Product change information (PCN)

PCN No.:	CAA180013	Date:	09.04.2018
Product:	(G)MSTB 2,5-EX, (G)FKC 2,5-EX, IC 2,5-EX

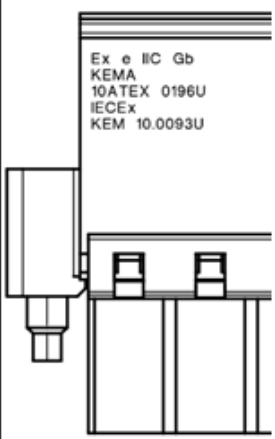
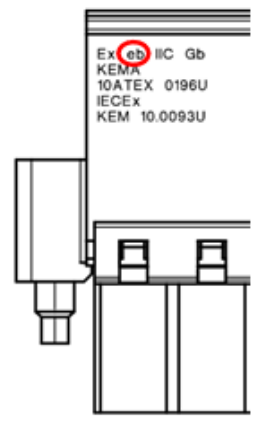
Description of changes		
<input checked="" type="checkbox"/> Product appearance (fit)	<input type="checkbox"/> Product geometry (form)	<input type="checkbox"/> Product function (function)
Change of lettering field		
<p>The new IEC 60079-7:2015 standard replaces the IEC 60079-7:2007 standard. Therefore, "b" will be added to the Ex printing of the affected products according to the new standard designation. Only the printing on the products is being changed, the technical data is unaffected by the change.</p> <p>The 6-month information period cannot be kept because validity of IEC 60079-7:2007 expires. Provisions are made to safeguard existing products.</p>

Previous production status	New production status
 <p>Ex e IIC Gb KEMA 10ATEX 0196U IECEX KEM 10.0093U</p>	 <p>Ex eb IIC Gb KEMA 10ATEX 0196U IECEX KEM 10.0093U</p>
